CRIME IMPACT STATEMENT

UNICORN HOUSE, CHEETHAM STREET, MIDDLETON
CONVERSION TO 11 no. RESIDENTIAL APARTMENTS

VERSION A: 13/09/2024

REFERENCE: 2024/0305/CIS/01

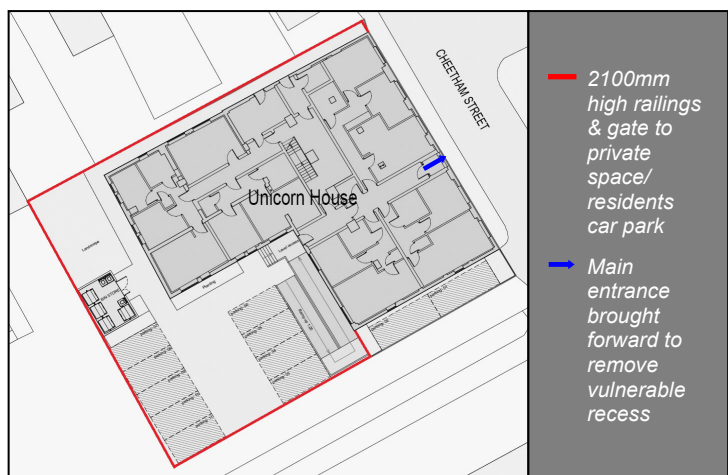
- 3.3.1 The access route to the rear of the building (serving the rear car park) is narrow, partially unmade and unlit. It benefits from limited levels of passive surveillance and direct overlooking, which could leave hidden doors, windows and parked vehicles potentially vulnerable to attack unseen if the rear of the site is left open/accessible to all. The north side and rear of the building should be enclosed with 2100 high railings & gates to prevent unauthorised access to all but residents (see illustration opposite and Section 4.5 for more information). The vehicular entrance to the car park (off the rear access route to the south) should be fitted with an automatic vehicular gate/s operated by resident key fob/proximity reader with no automatic egress (i.e. access control both 'in' and 'out'), so that criminals cannot gain access to the area, attack the rear of the building or the parked vehicles unseen and escape. Any pedestrian gates to the area (off Cheetham Street or the rear access route) should be for the use of residents only and should be single-leaf, self-closing/locking and operated by resident key or fob (again, see Section 4.5 for more information).

3.3.2 The 2 no. parking spaces along the southern gable of the building (marked as 'Parking 01' & 'Parking 02' on the proposed site plan), will not be capable of being located within the secure car park describe above. As a result, these space hidden to the side of the building could leave the vehicle vulnerable to attack unseen. At the very least, lighting should be provided to the spaces (see Section 4.6) and windows to Apartments 2, 3, 8 & 9 should overlook them as much as possible (with additional protection to the windows themselves, as described below).

3.3.3 As proposed, the ground floor windows to the apartments along the Cheetham Street frontage and southern gable of the building (i.e. to Apartments 1, 2 & 3) will front directly onto the street/rear access road and will not be protected by enclosed by any defensible space – leaving them exposed and vulnerable to unauthorised access, damage and nuisance/anti-social behaviour, as well as a lack of privacy for residents. Ideally, such windows should be protected by defensible space (defined by low railings and planting), in order to deter unauthorised access/nuisance/anti-social behaviour and funnel any pedestrian movement away from them. Clearly defined defensible space between such residential windows and the public realm provides a degree of separation between public and semi-private space and acts as a psychological barrier to some offenders, who are more likely to feel under observation/scrutiny if they enter or cross the space. Such boundary definitions can also reduce the risk of criminal damage. However, it is noted that this is not achievable at this site. It is therefore highly recommended that at least the lower portion of the windows are protected by balustrades, ornate bars or planters (see opposite for some examples), to provide a visual deterrent and deter criminal damage and nuisance, as well as provide a degree of privacy for residents. When residents do not feel

3.3.4 The main communal entrance to the building will be deeply recessed, accessed via steps up off the street. As a result, the entrance will be partially hidden from the street (where it could be attacked unseen) and located within a publicly accessible sheltered space that could foster loitering/gathering to the nuisance/intimidation of residents and legitimate visitors. It is highly recommended that the communal entrance to the building is brought forward to the front building line (see illustration above), with any steps provided internally within the entrance lobby, to remove any potentially vulnerable recess and maximise surveillance opportunities. The communal entrance itself should be formed by a single-leaf, self-closing doorset secured with a multi-point electronic lock permitted as part of the security-certification, to operate remotely via an access control system. There should also be a secure system for the delivery of post that does not require access to all floors of the building. Given the emerging trend of parcel thefts (particularly at apartment blocks), it is highly recommended there is a secure system for depositing parcels (see Section 4.1 for more information).

- ☐ All ground floor and any potential accessible upper floor windows should be compliant with and certified to BS PAS 24.
- ☐ The ground floor residential windows to Apartments 1, 2 & 3 (i.e. those that cannot be protected by defined defensible space along the street/rear access route) should be non-opening and protected by bars or balustrades as described within Section 3.3. All other ground floor opening lights should be key-lockable (escape requirements permitting) and have fixed/lockable opening restrictors (not releasable from the outside) limited to 100mm.

- ☐ The north side and rear of the building should be defined and enclosed as a private, resident-only space with walls and/or railings and lockable gates to a height of 2100mm from external ground level. Care should be taken to ensure that panels are fixed securely to the posts and that any level changes do not inadvertently facilitate climbing or leave large gaps underneath the panels/gates. There should be no centrally located horizontal bars to aid climbing and there should be no immediately adjacent climbing aids. Any boundaries formed by a combination of walls and railings should have railing panels that are fixed flush with the outer skin of the brickwork below, leaving no steps/gaps that would provide a climbing aid.

- 
- ☐ The vehicular access/egress point to the rear parking area should be fitted with a 2100mm high automatic vehicular gate/s (ideally a sliding gate), to prevent unauthorised access. The vehicular gate/s should be operated using a key fob/proximity reader system with no automatic egress (i.e. access control both 'in' and 'out'), so that criminals cannot gain access to the area, attack the vehicles or the building and escape. It should have no centrally located horizontal bars to aid climbing and the gate/s should be located away from any other climbing aids. If double gates are used, they should overlap when closed and should not be capable of being forced open. The access-controlled vehicular gate/s should be regularly maintained and immediately repaired/replaced if it fails, in order to continue preventing unauthorised access to the rear of the site.
